Pit 29, M-1980-183, Inspection Report

Re: M-1980-183 April 12, 2019 Inspection Response

FIGURE F-1 - RECLAMATION PLAN

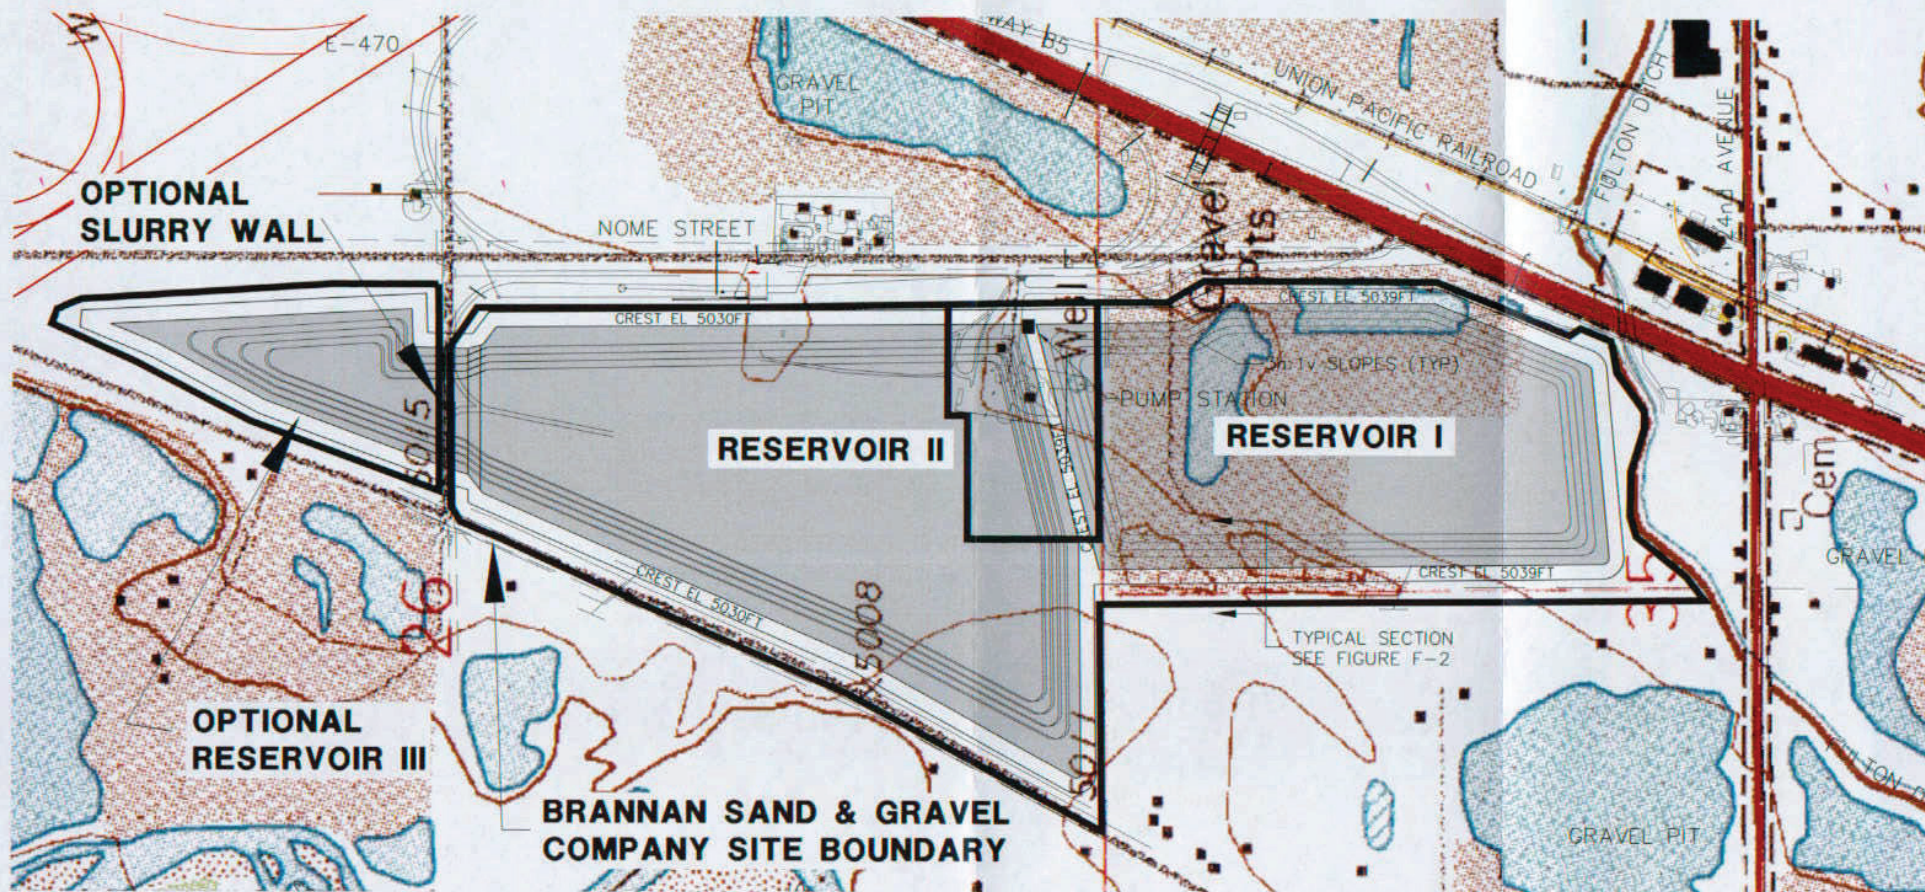
As noted in your report, we will work with the reservoir operator (Bromley) to complete the required earthwork necessary to regrade the affected pit slopes in Mining Area II so they comply with the 3H:1V ratio, as approved in AM-01.

Finally, Brannan will revegetate the area around the reservoir in Mining Area I with the approved seed mixture defined in the permit, and will work with the reservoir operator (Bromley) to revegetate the area the reservoir in Mining Area II once the slopes for that reservoir have been regraded to specifications.
